AP1000 Design Certification Review

Westinghouse Electric Company

Advisory Committee on Reactor Safeguards

June 3, 2004

Issue 6: Organic Iodine Production

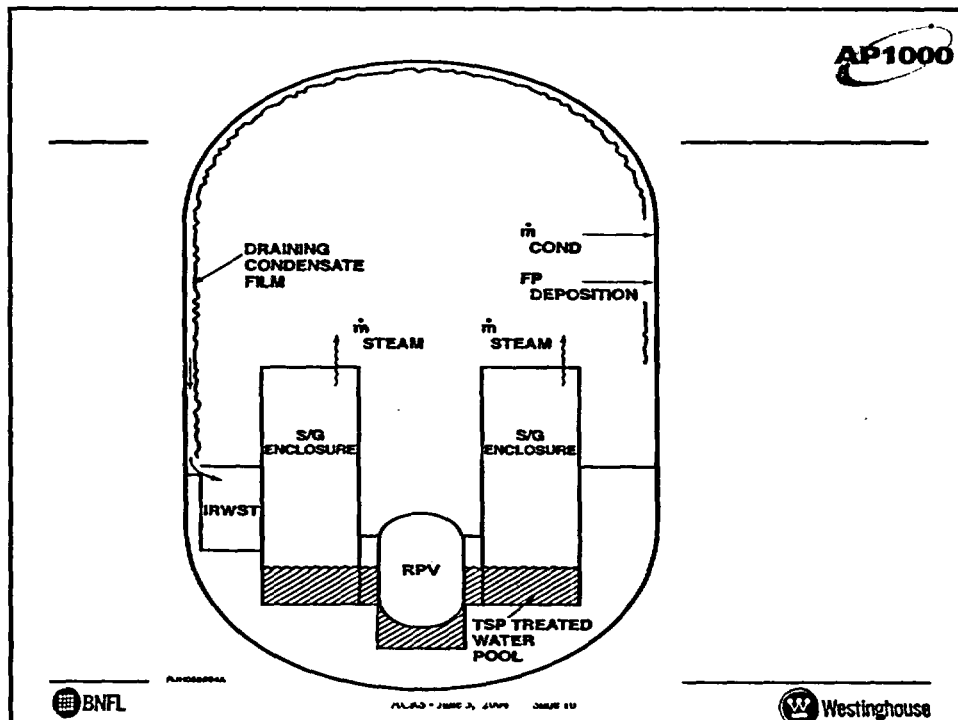
Organic Iodine Production: The acidification of containment water as a result of radiolysis of organic material could give rise to significant airborne fission product iodine in gaseous organic form. We need to review how Westinghouse and the staff have dealt with this potential.

- Formation of organic iodine as a result of radiolysis or organic materials involves the availability of elemental iodine (I_2).
- Elemental iodine can be produced from iodide (I^-) in water pools or films where pH is not controlled to be 7 or greater.

- AP1000 containment design includes TSP to control the pH of the water pool that collects in the lower compartment and reactor cavity following an accident.

- However, no specific pH control treatment for the condensate film draining down the containment dome and shell is provided.
- Cesium iodide can be deposited on the draining film and provide a source of I^- that could potentially be converted in the film to I_2 given the film was acidified.

- Film residence time depends on the steam condensation rate and limits the amount of film acidification and CsI deposition. A range of 40 to 260 seconds has been estimated for condensation rates of 29 to 2.3 kg/s.

Issue 6: Organic Iodine Production

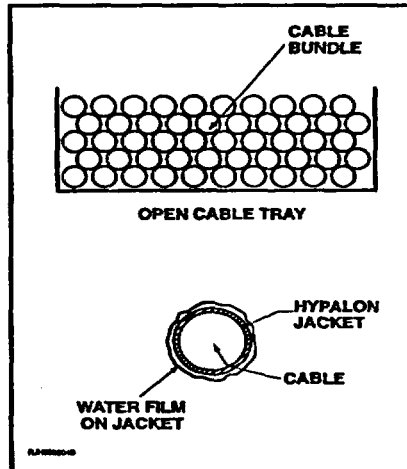
- Radiolytic decomposition of electric cable jacket material can produce HCl. If the HCl could escape the uncovered and covered cable trays, it could eventually mix with the containment atmosphere and be delivered to the draining film with the condensing steam.
